ADDENDUM NO. 03

**Kalamazoo Public Schools Loy Norrix High School Mechanical Improvements
606 East Kilgore Road
Kalamazoo, MI 49001**

ADDENDUM NO. 3

PROJECT: Loy Norrix High School Mechanical Improvement D Wing
606 East Kilgore Road
Kalamazoo, MI 49001

SHEET NUMBER
A 301
23-637.00

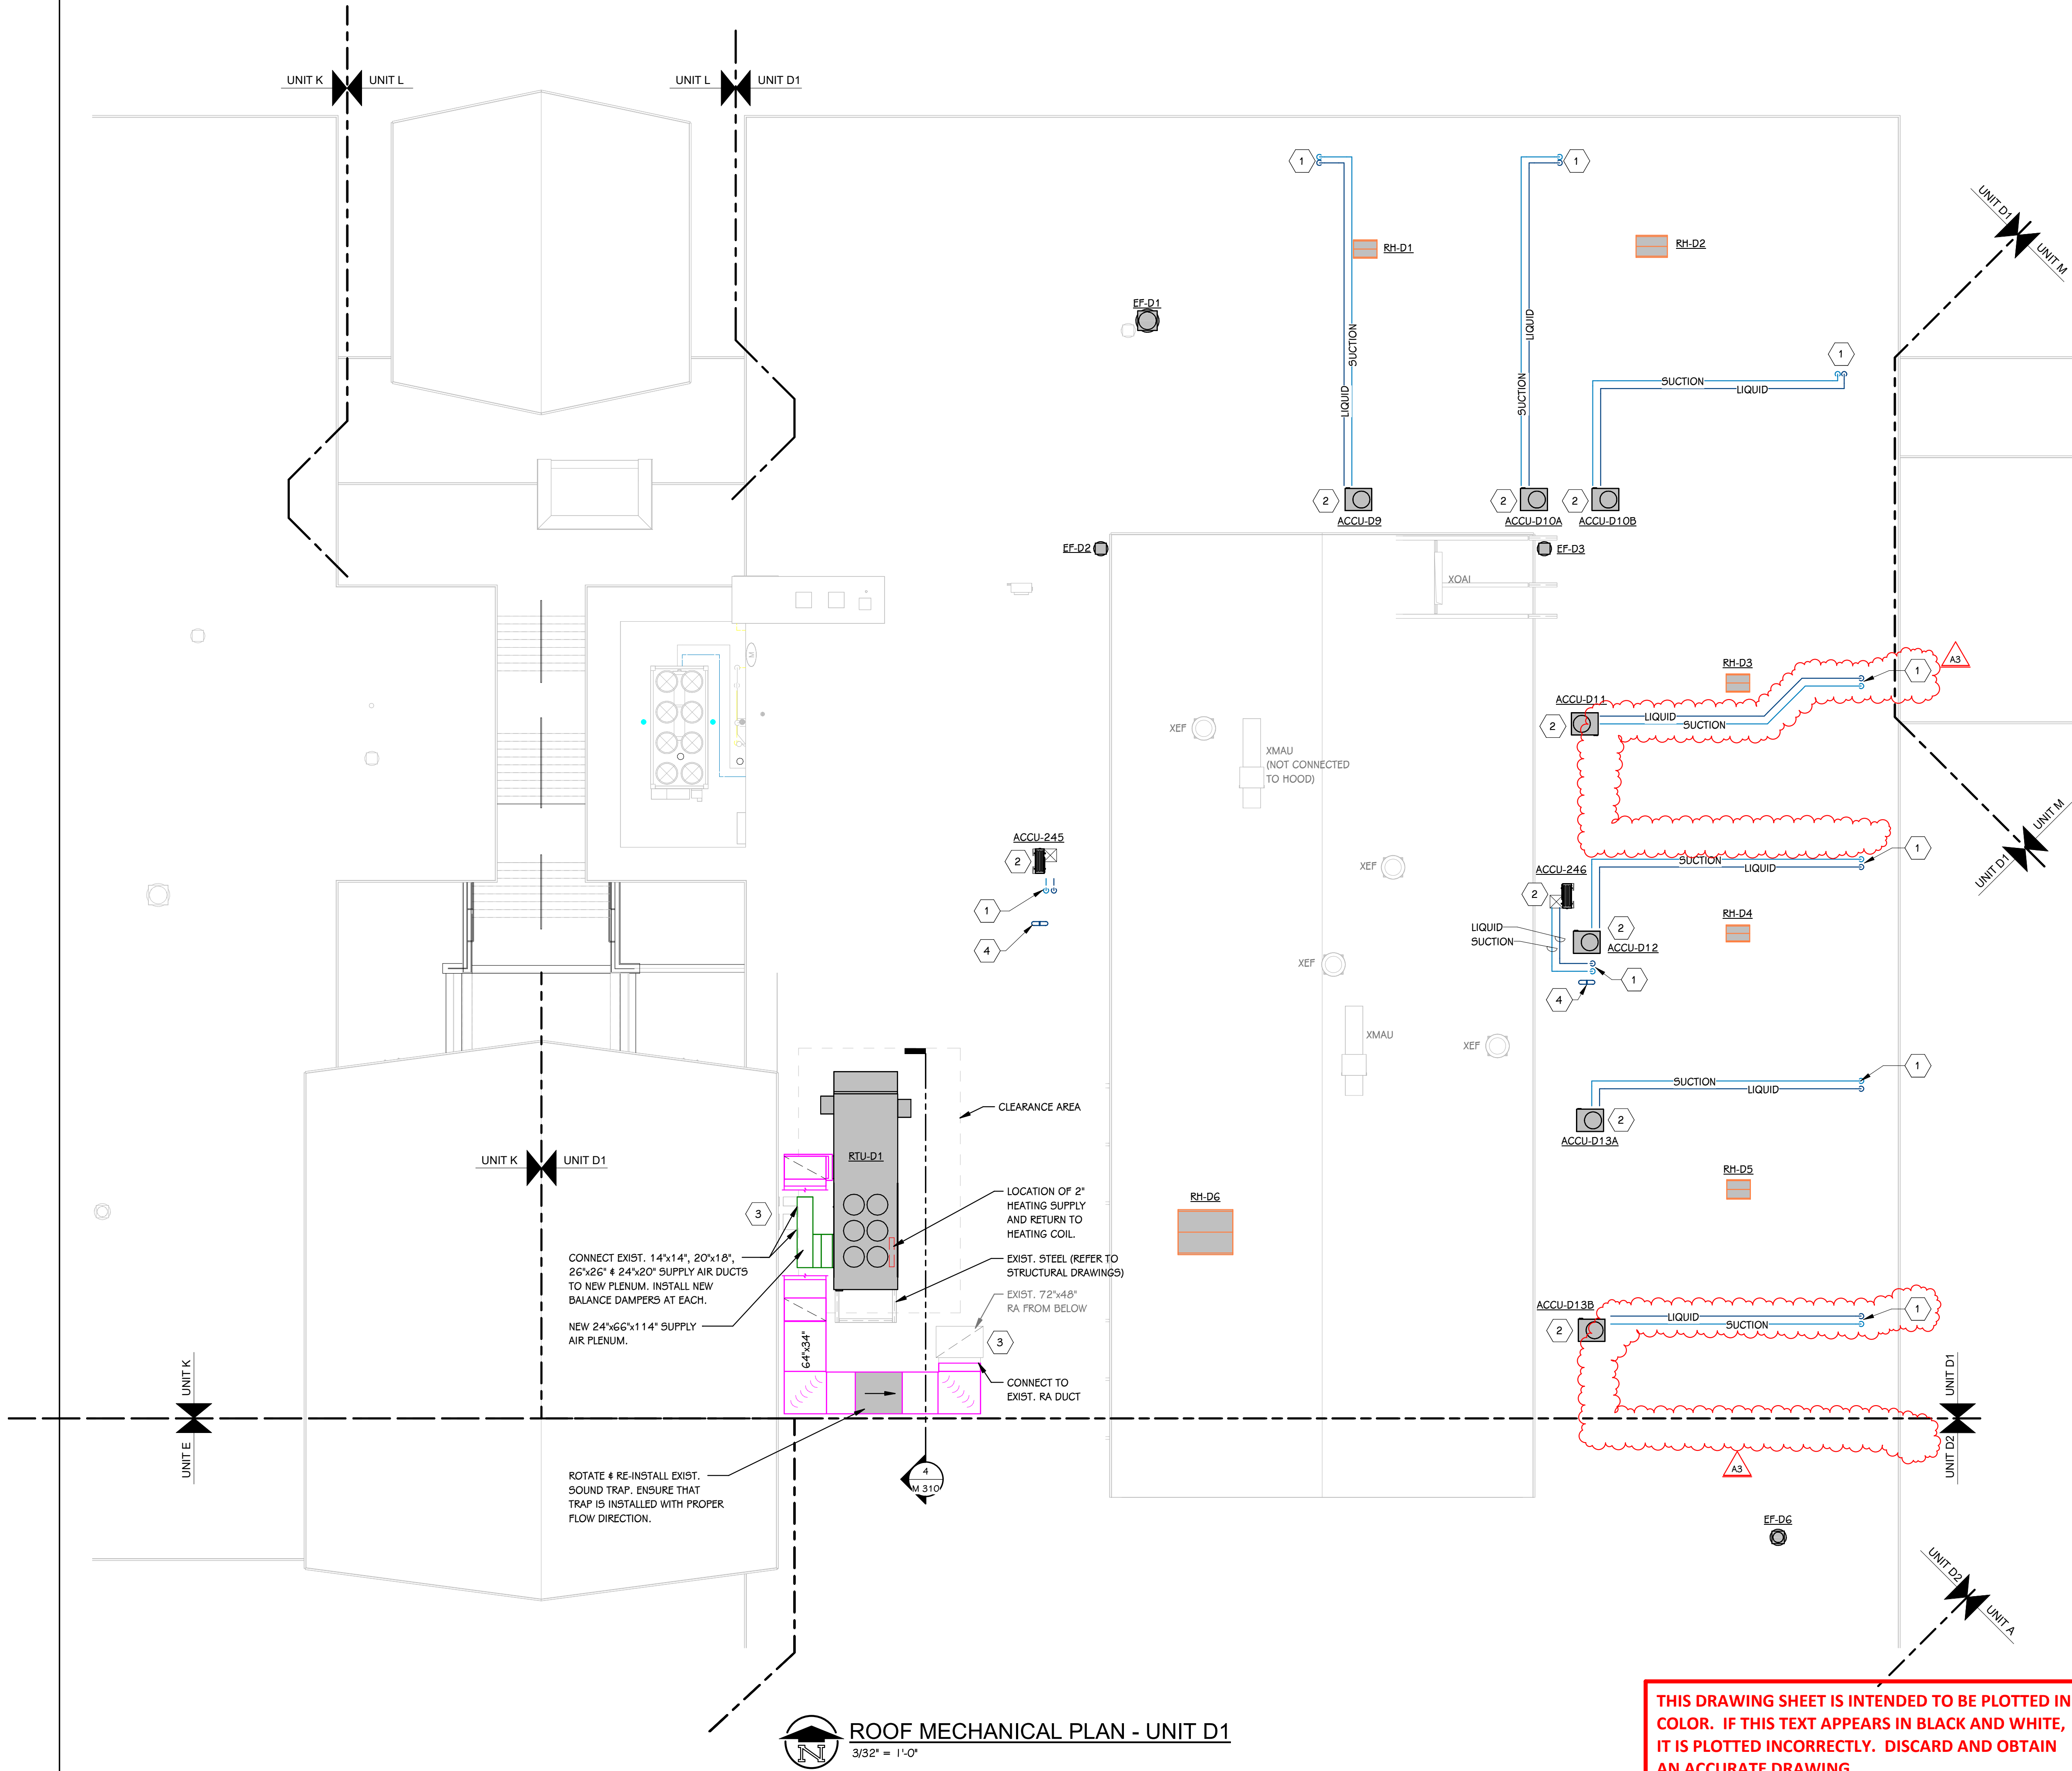
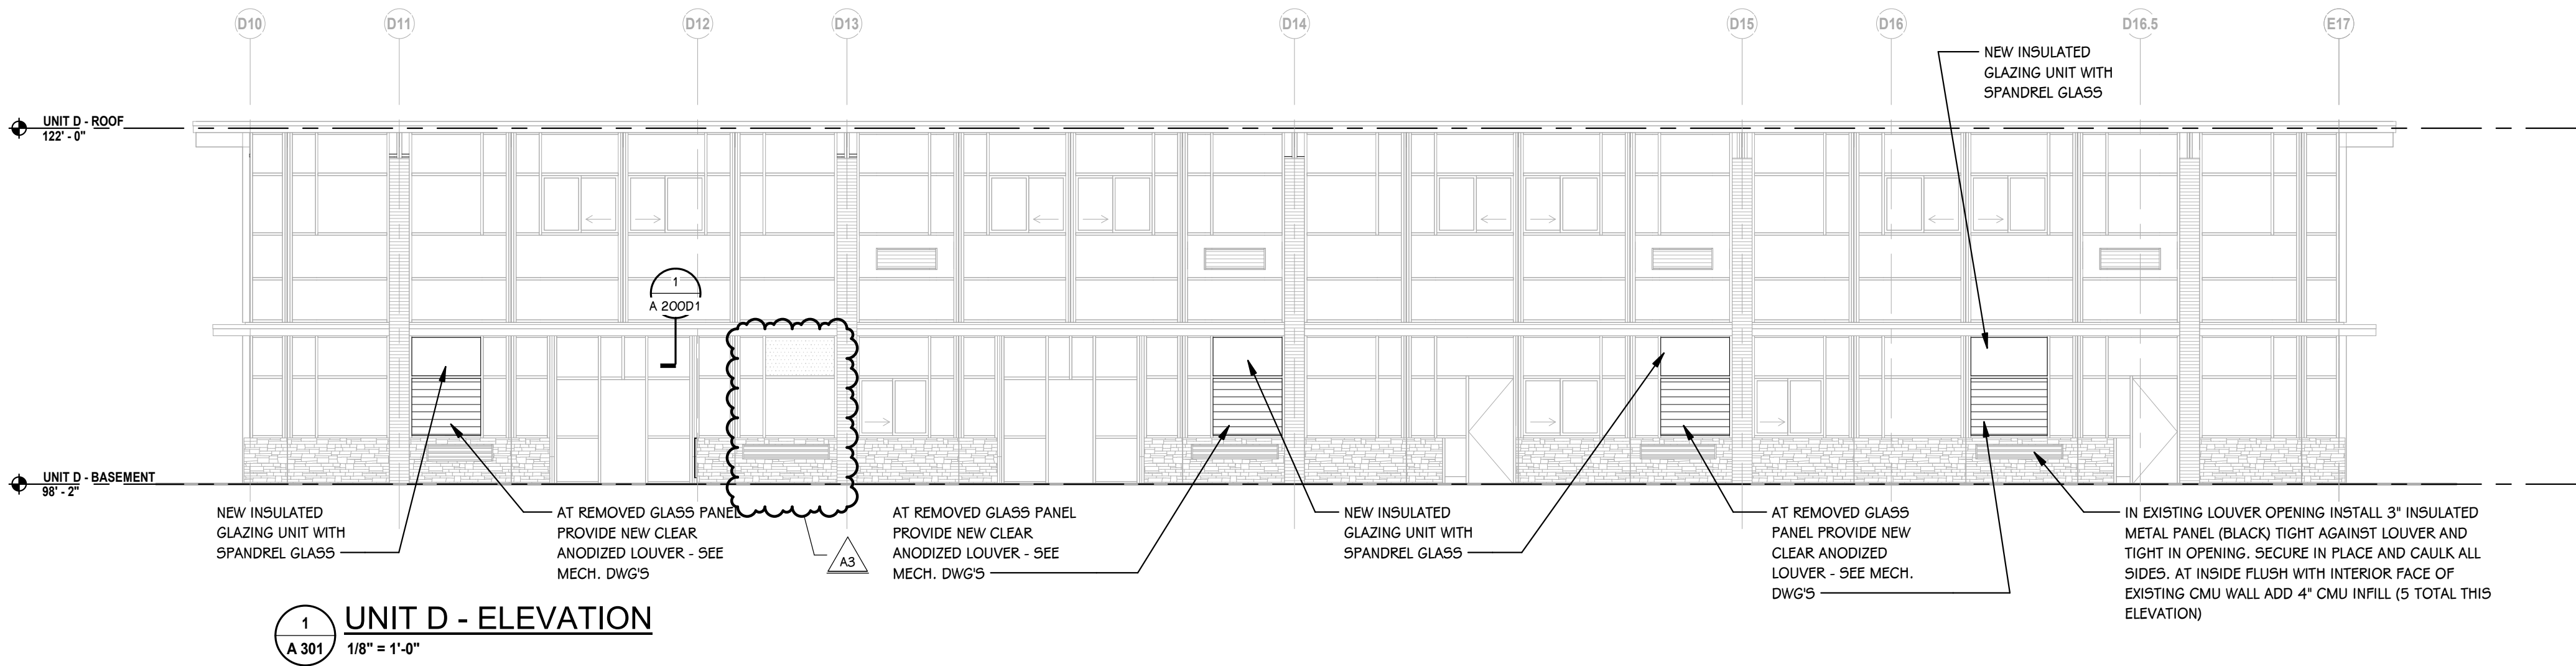
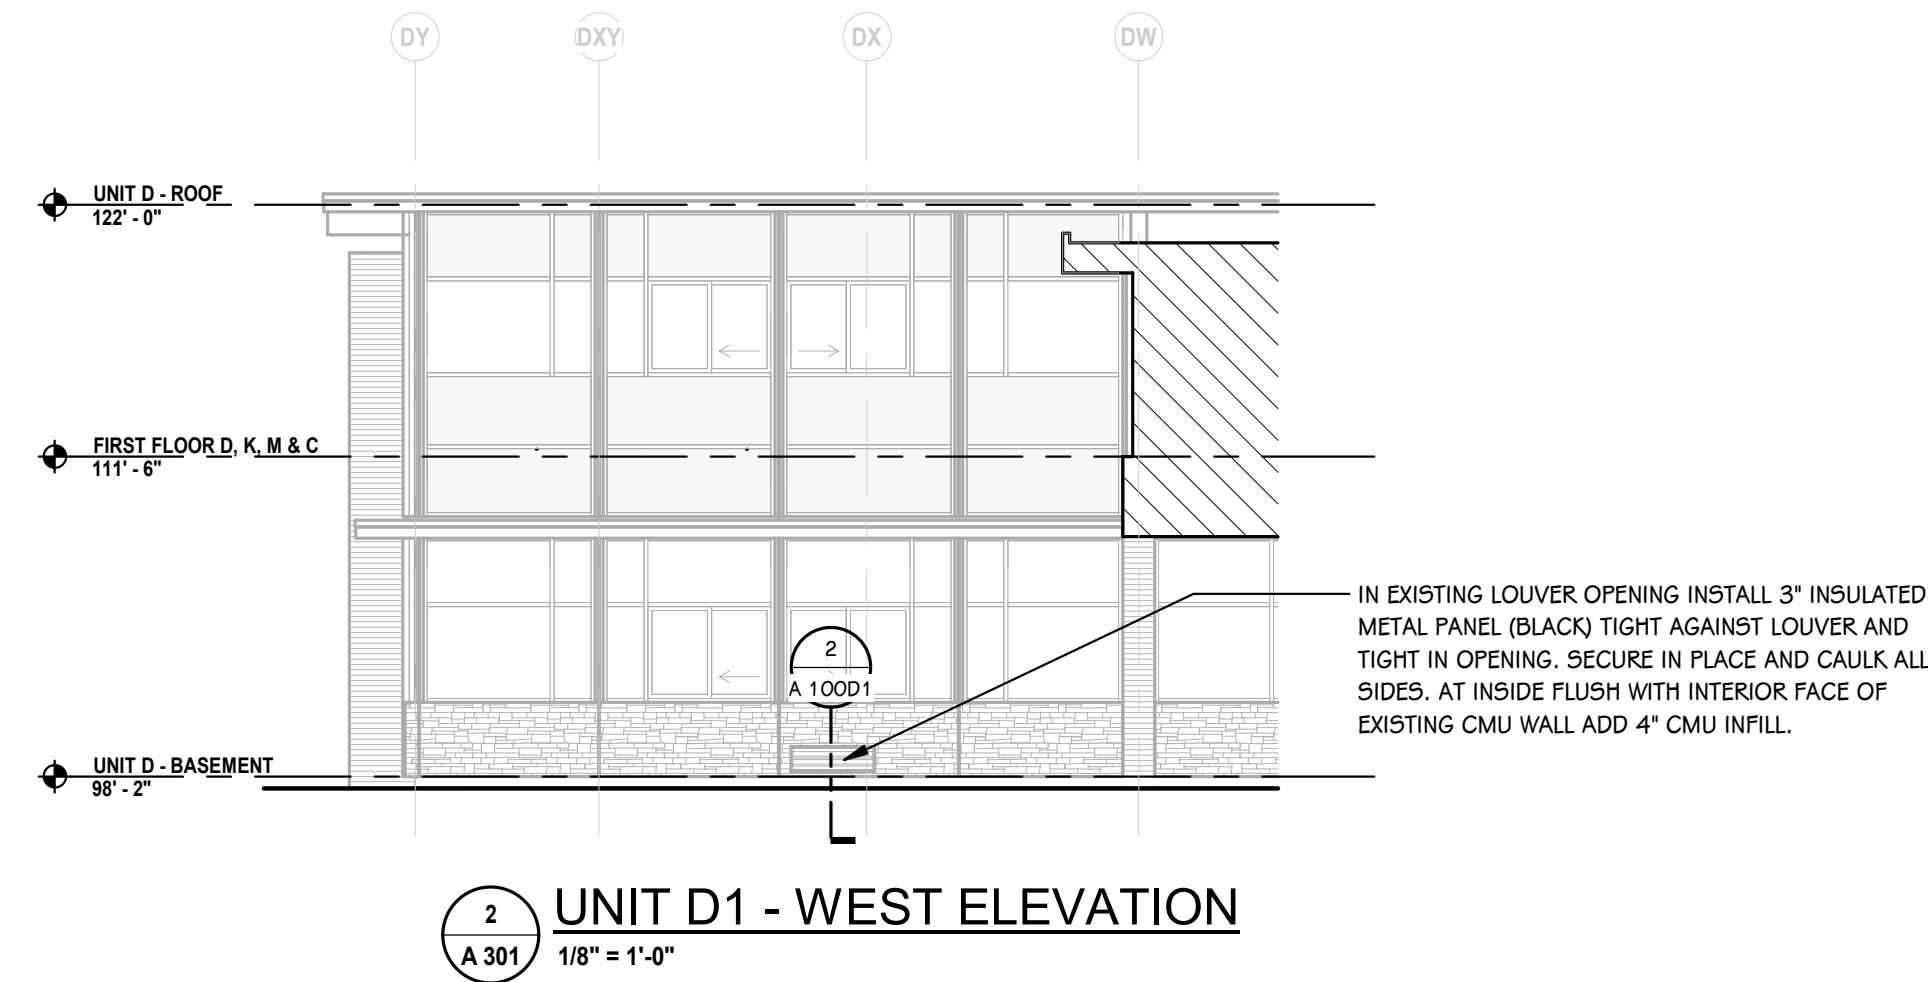
ADD-3 Item No. D-1 - Coordinated the Removed Infill Panel and Louver Quantities

Updated exterior elevations to reflect the correct number of infill panels and louvers to be installed to match the exterior demo sheets.

SHEET NUMBER
M 150D1
23-637.00

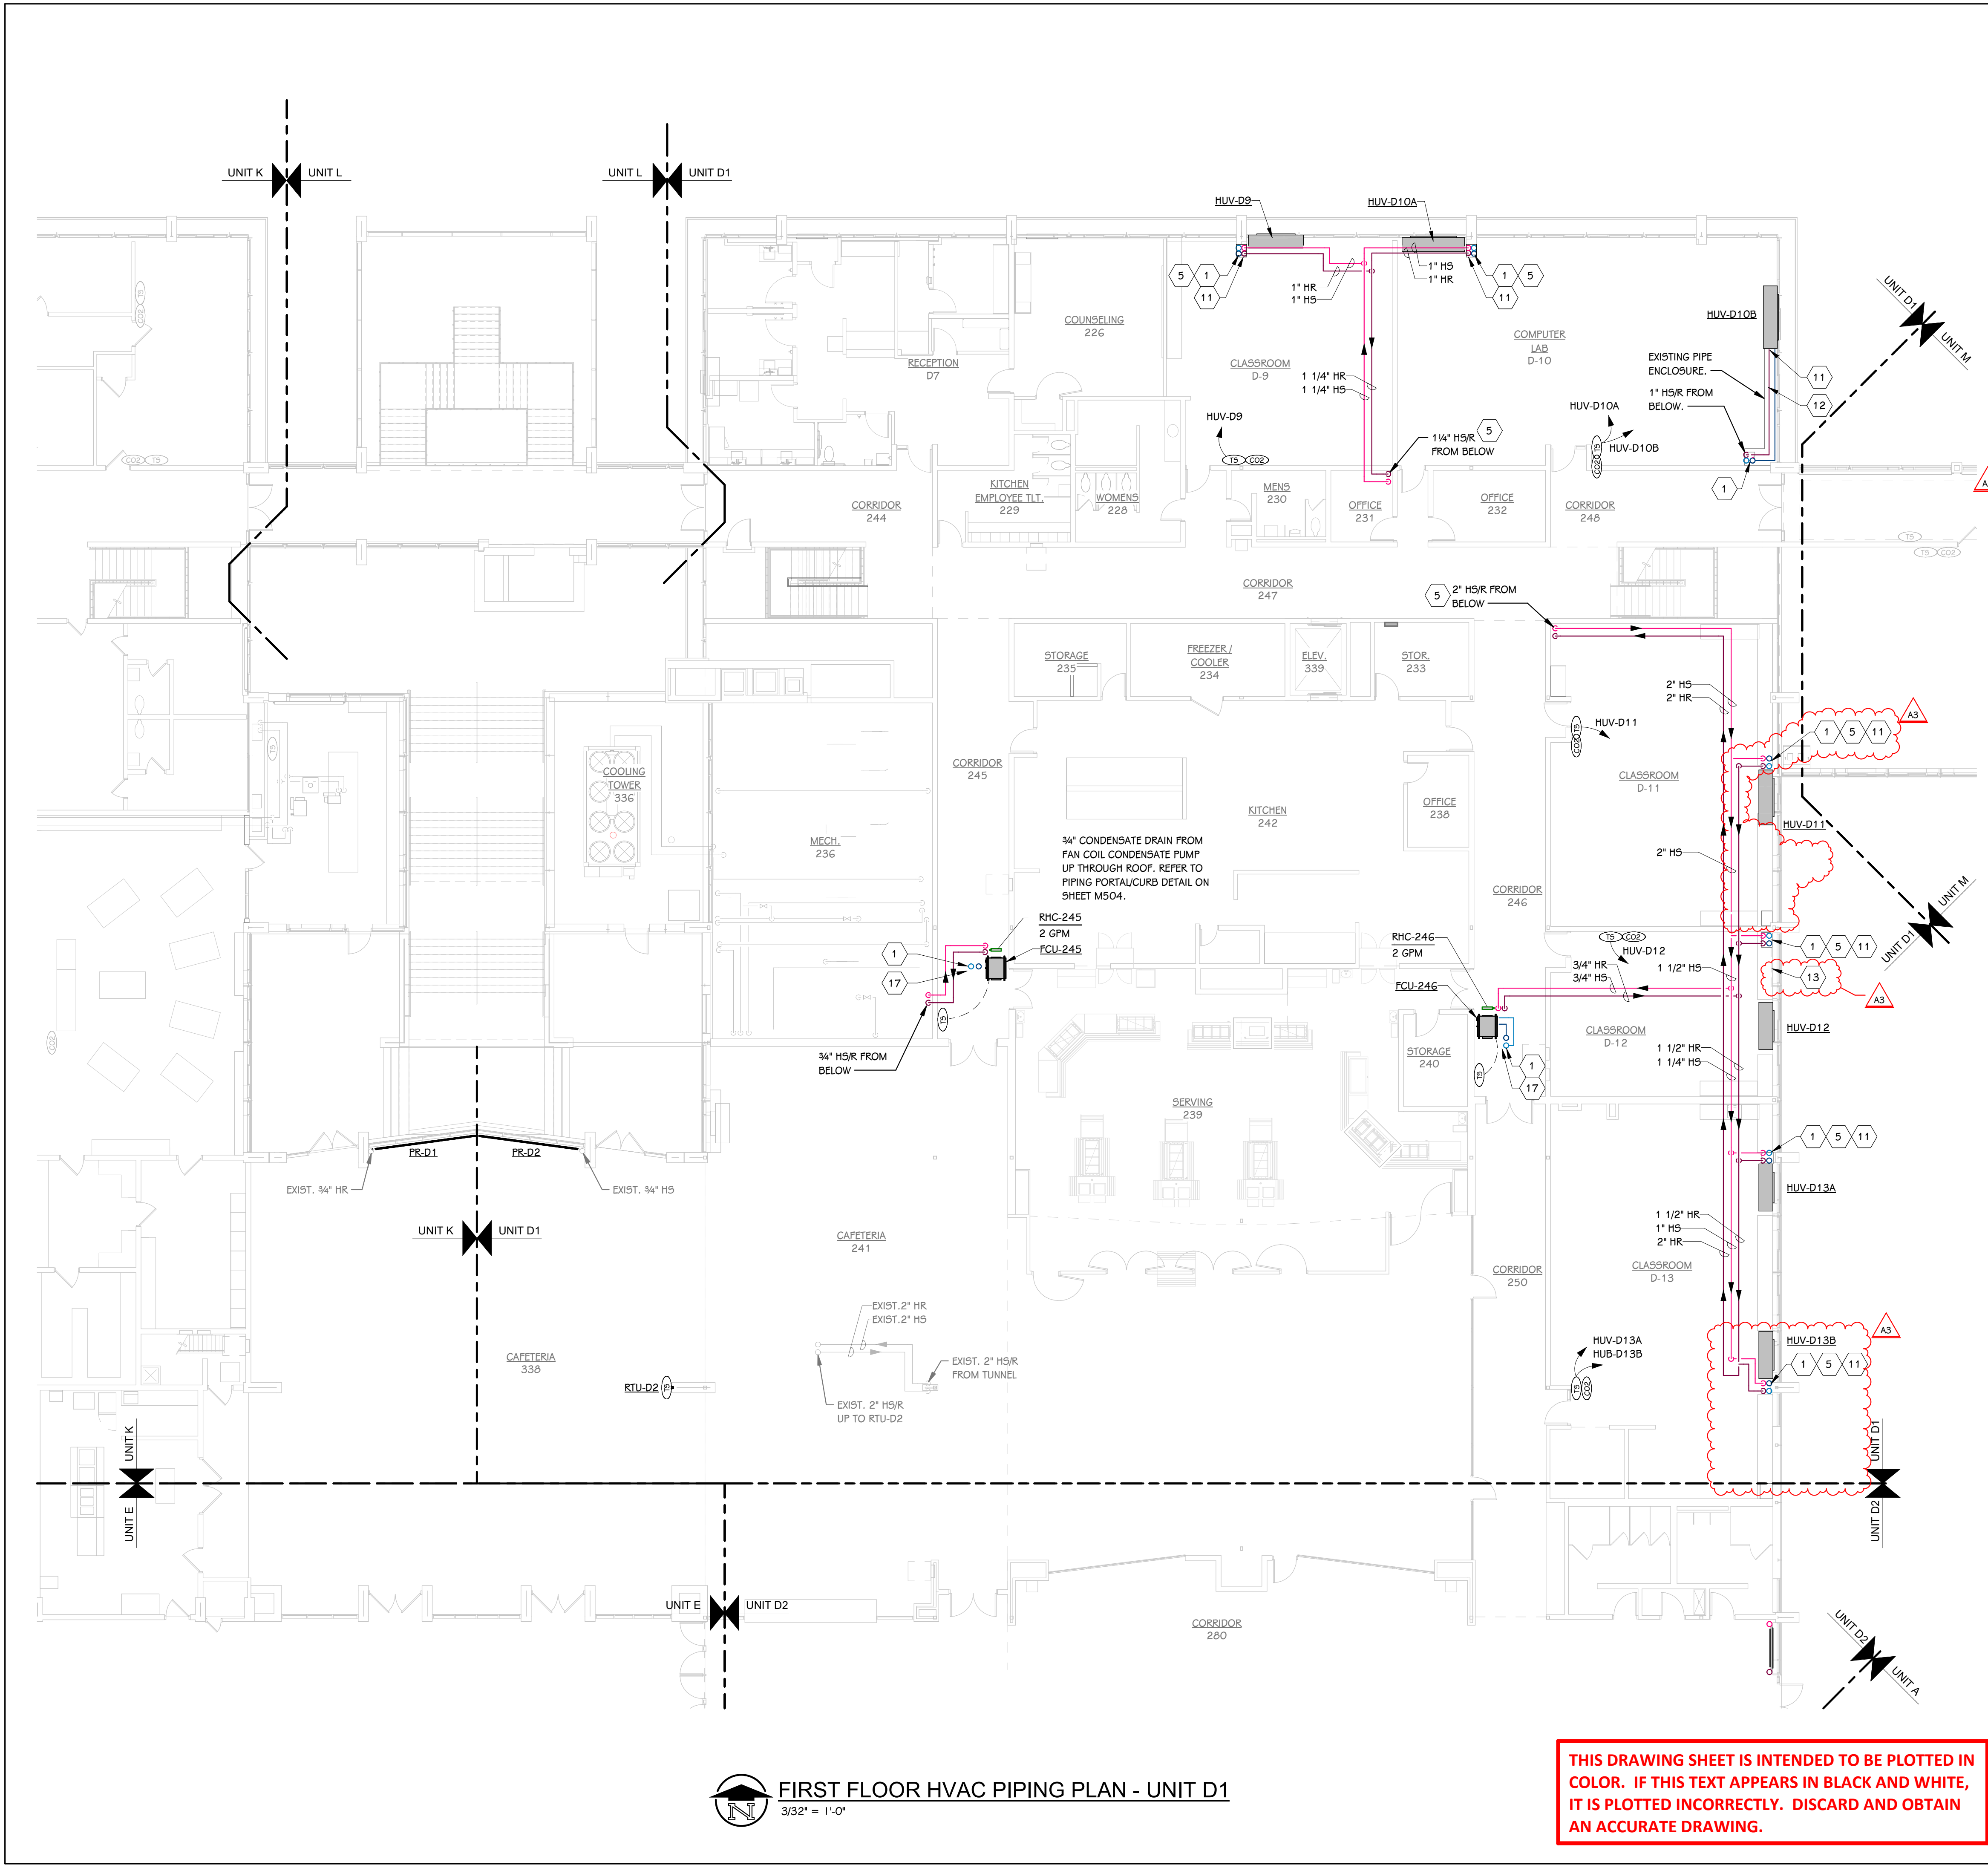
ADD-3 Item No. D-4 - Updated Pipe Locations

Relocated piping in Classrooms D-11 and D-13, refer to drawings above for new locations.
